Access Compliance Report

Public Rights-of-Way

Intersection ID: 42772	Main Street: JEANETTE_CR	Cross Street: SWANSONG_LN	Location: W
ADA ID: CCA7F79362E6	Ramp Type: PerpDiag	Initial Pass/Fail: Fail	Overall Compliance: No
Severity Score: 17.5			
Codes/Mitigation Info/Possible Solution		Field Measurements/Component Compliance

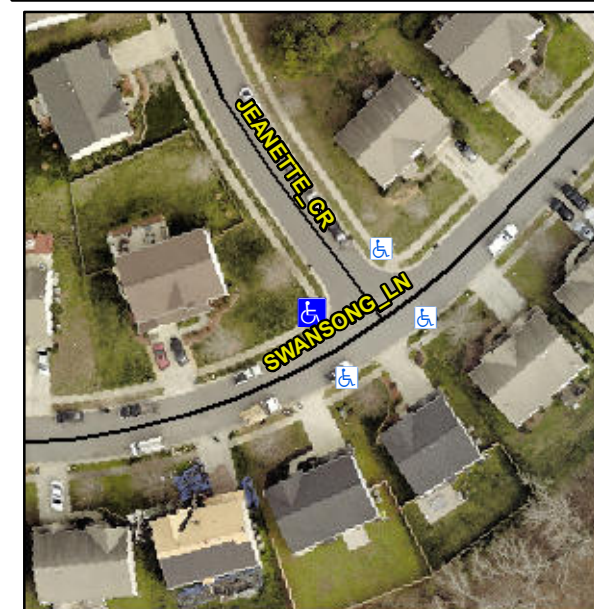
Not Found, R304.5.1

Compliance	Description	Data	Compliance	Description	Data
N/A	Ramp Length (in)	46.5	Yes	Ramp Slope (%)	6.2
No	Ramp Width (in)	35.0	Yes	Ramp XSlope (%)	0.4
N/A	Flare Type LT	N/A	N/A	Flare Type RT	N/A
N/A	Flare Slope LT (%)	N/A	N/A	Flare Slope RT (%)	N/A
N/A	Flare Traversable LT?	N/A	N/A	Flare Traversable RT?	N/A
N/A	Landing Length (in)	N/A	N/A	DWS Provided?	N/A
N/A	Landing Width (in)	N/A	N/A	DWS Contrast?	N/A
N/A	Landing Slope (%)	N/A	N/A	DWS Length (in)	N/A
N/A	Landing X Slope (%)	N/A	N/A	DWS Full Width?	N/A
N/A	Landing Curb? (Y/N)	N/A	N/A	DWS Offset (in)	N/A
N/A	Shared Landing?	N/A			
N/A	Gutter Ponding?	N/A	N/A	Gutter Slope (%)	N/A
N/A	Gutter Lip Ht (in)	N/A	N/A	Gutter X Slope (%)	N/A
N/A	Painted X Walk1?	No	N/A	Painted X Walk2?	No
	X Walk 1 Direction	To E		X Walk 2 Direction	To S
N/A	X Walk 1 Width (in)	N/A	N/A	X Walk 2 Width (in)	N/A
	X Walk 1 Slope (%)	1.7		X Walk 2 Slope (%)	0.1
	X Walk 1 X Slope (%)	1.6		X Walk 2 X Slope (%)	0.1

Remove & Replace Curb Ramp With Two New Directional Ramps or Equivalent.
